ROLLIN RIDGE Filing No. 1 Grading & Erosion Control Plans El Paso County, Colorado

Remove Filing 1 and replace with
Pre-Development Grading & Erosion Control
Plans.

ROLLIN RIDGE ESTATES - FILING NO. 1

**GEC PLAN
TITLE SHEET**

**DETENTION POND A
PLAN & DETAILS**

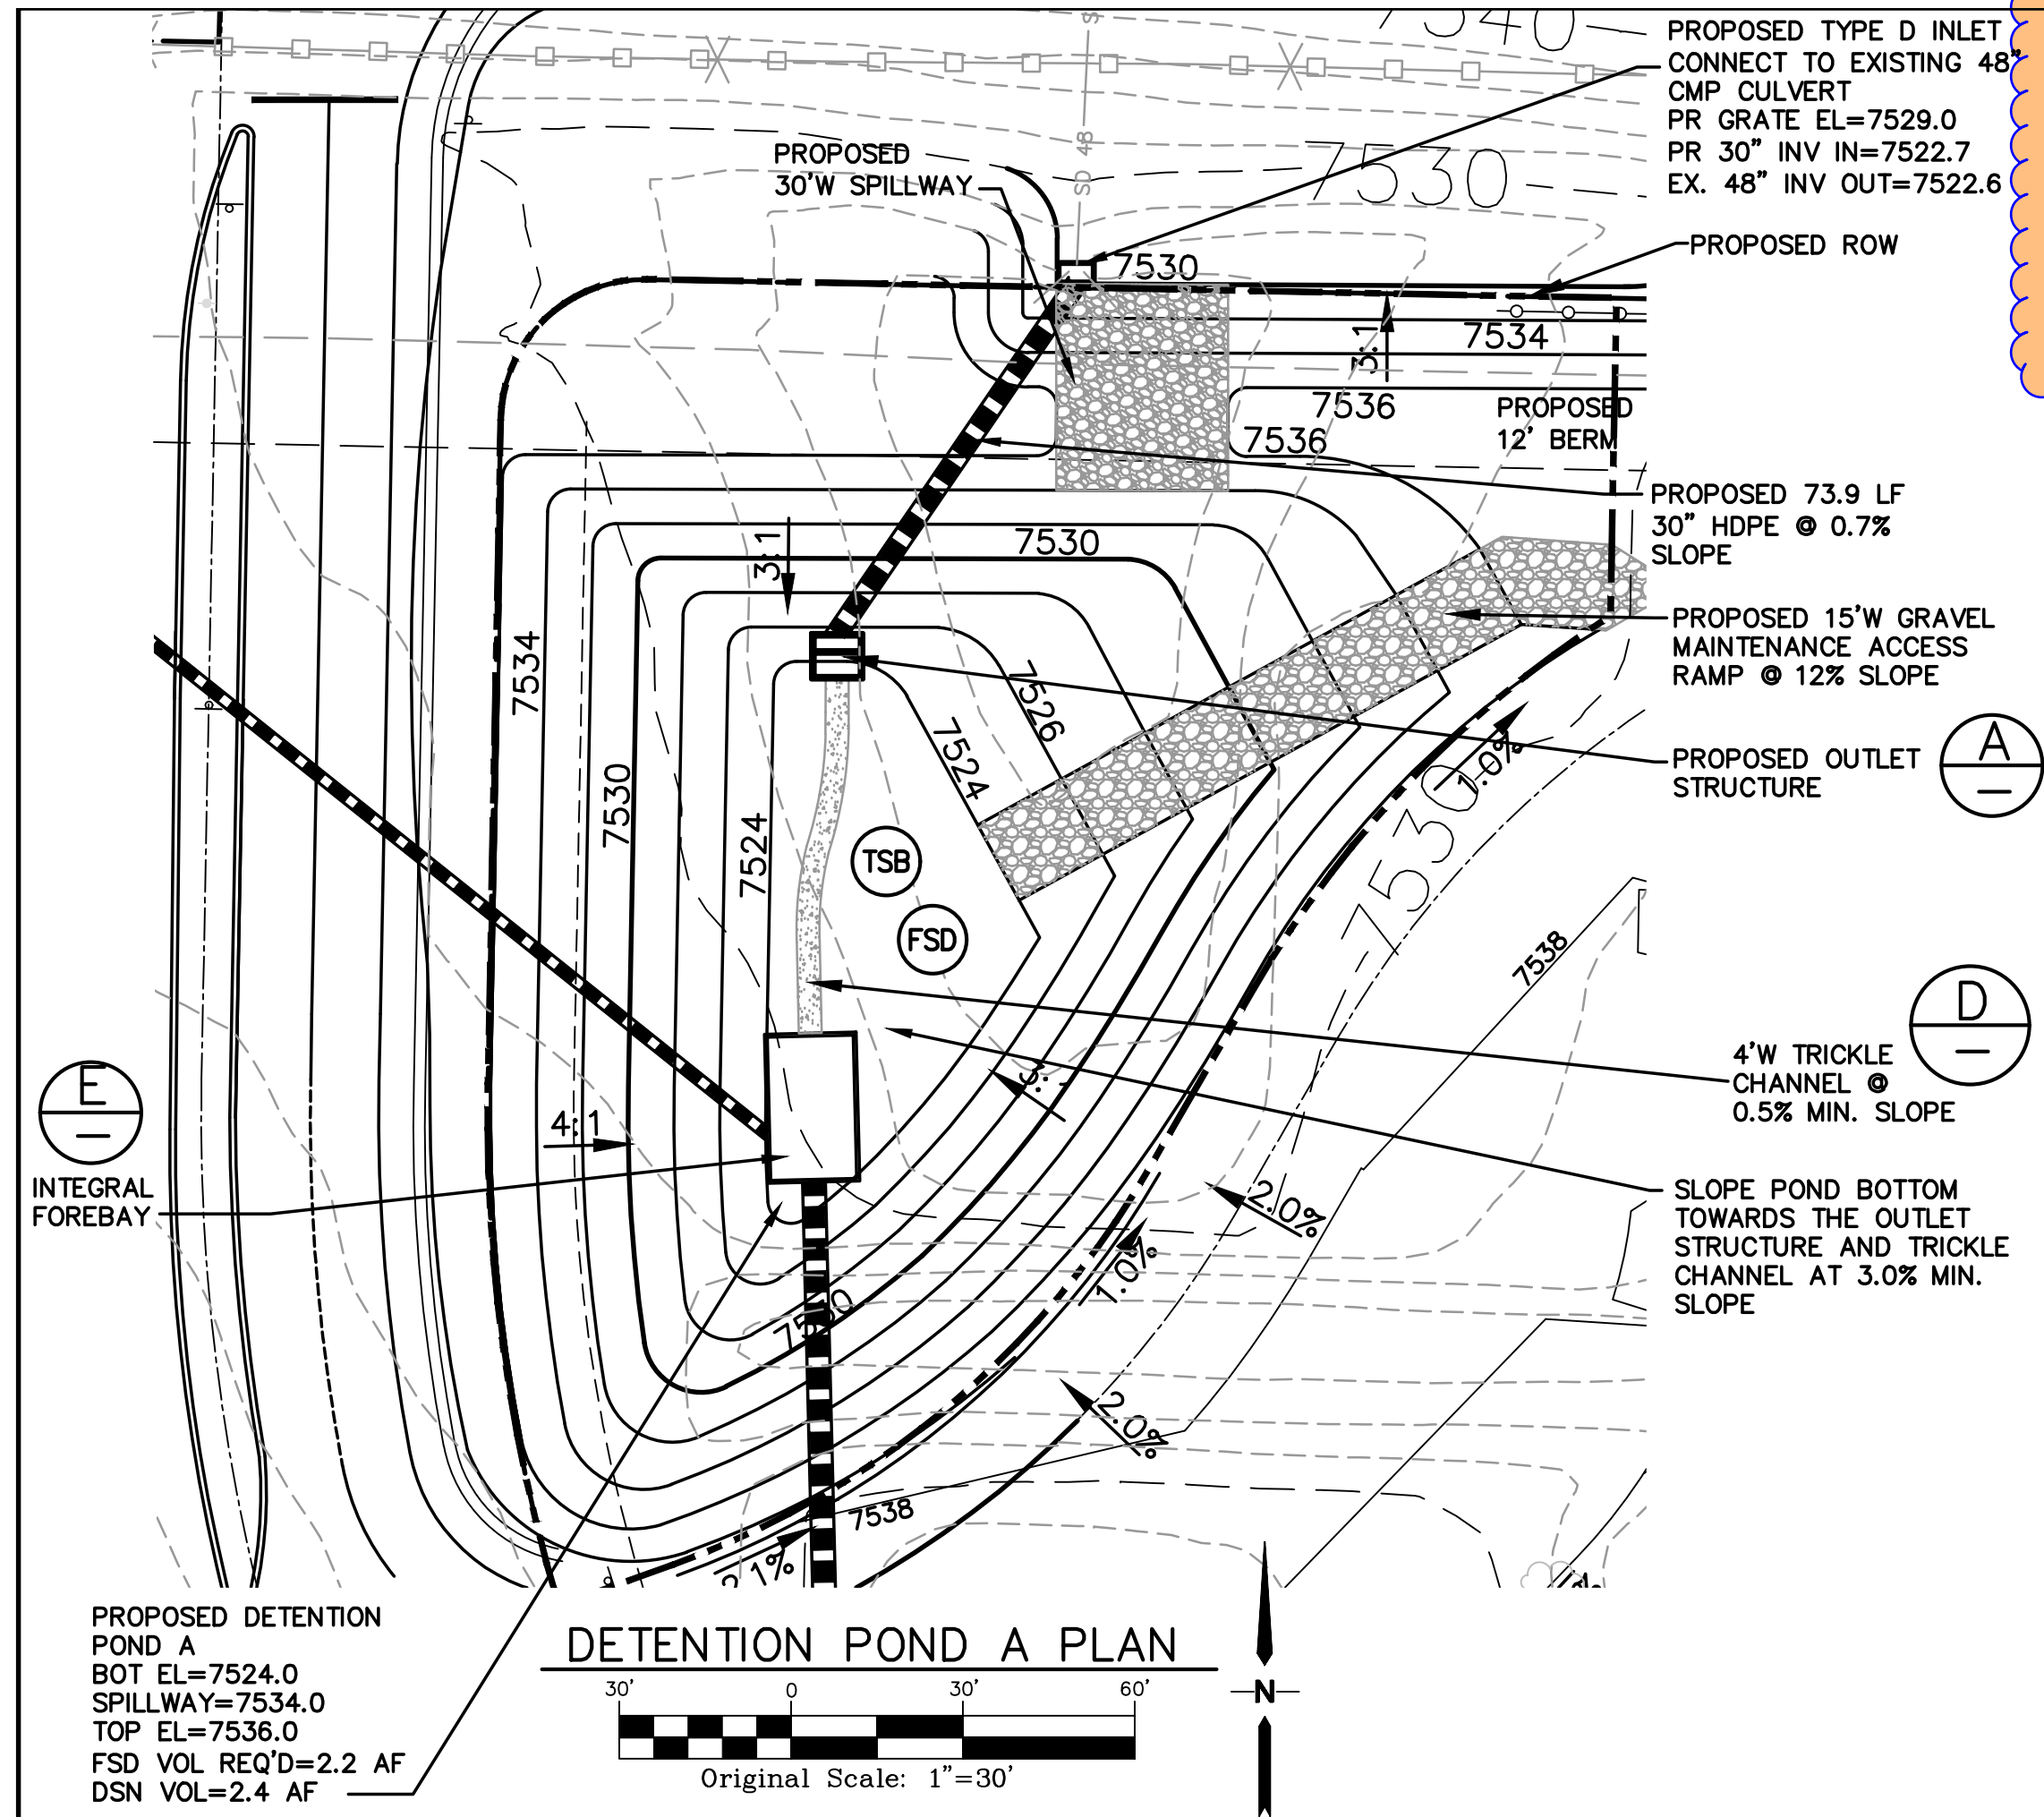
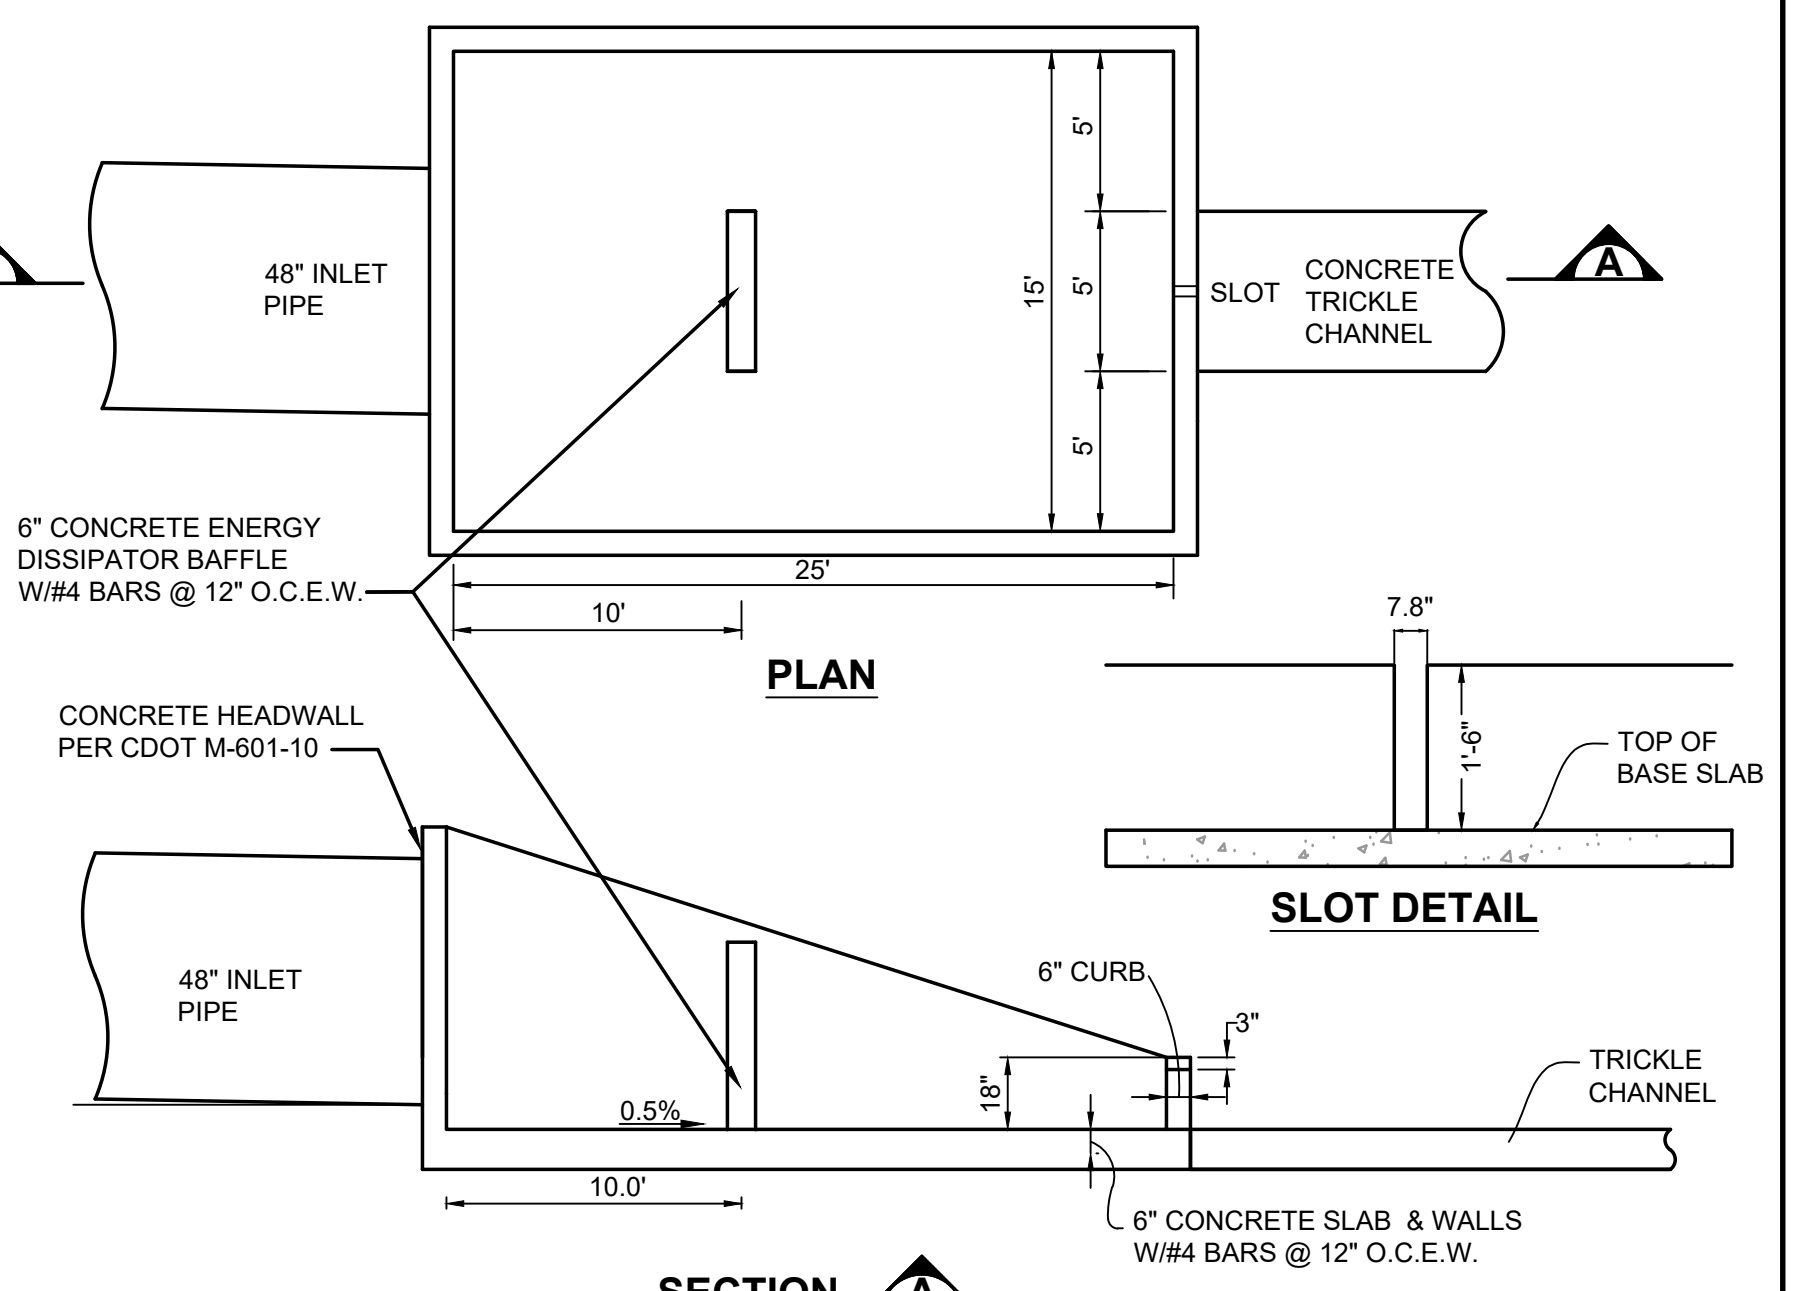
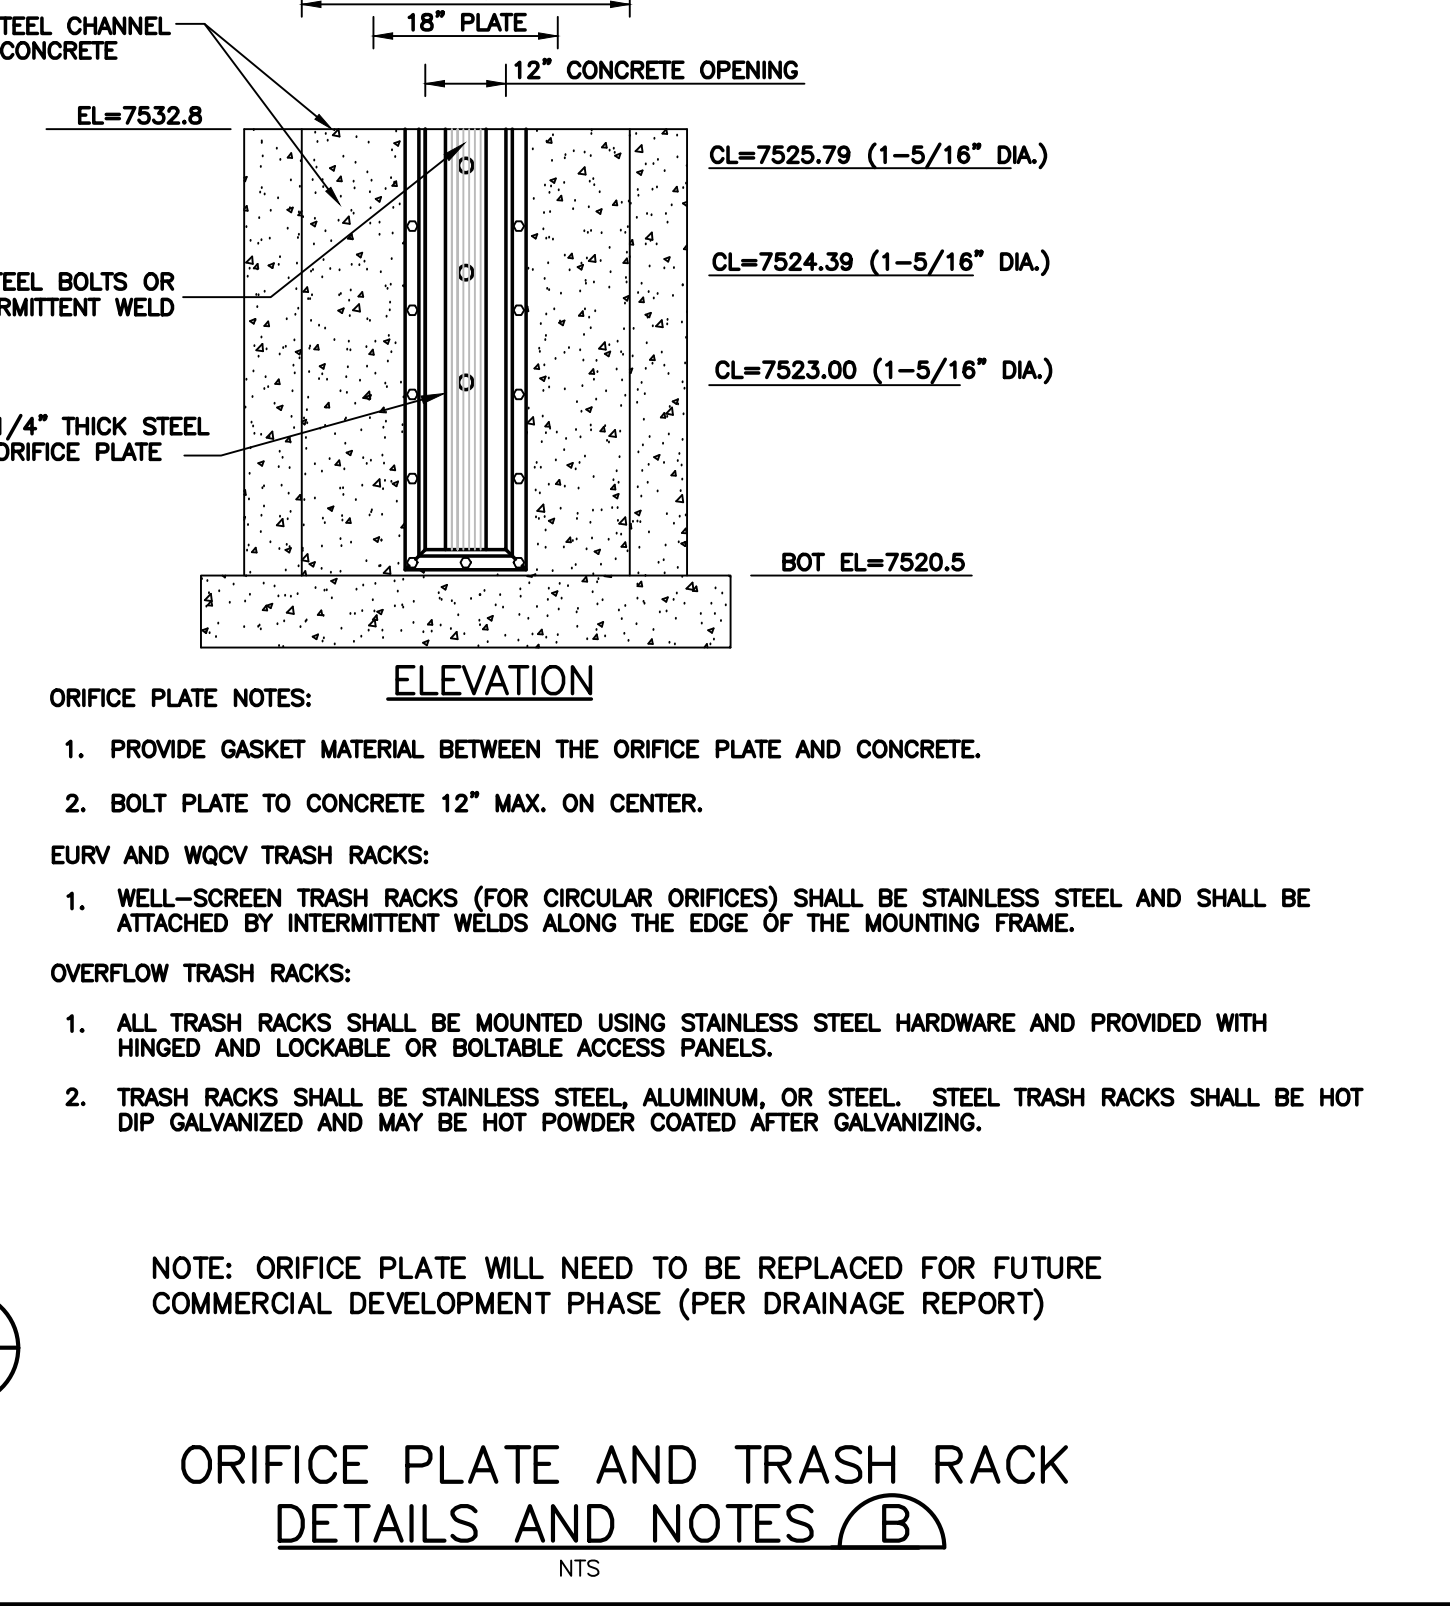
Keep this table for each TSB in plans for EGP

Remove permanent pond outlet structure details. These are approved with the Filing 1 application not the early grading application.
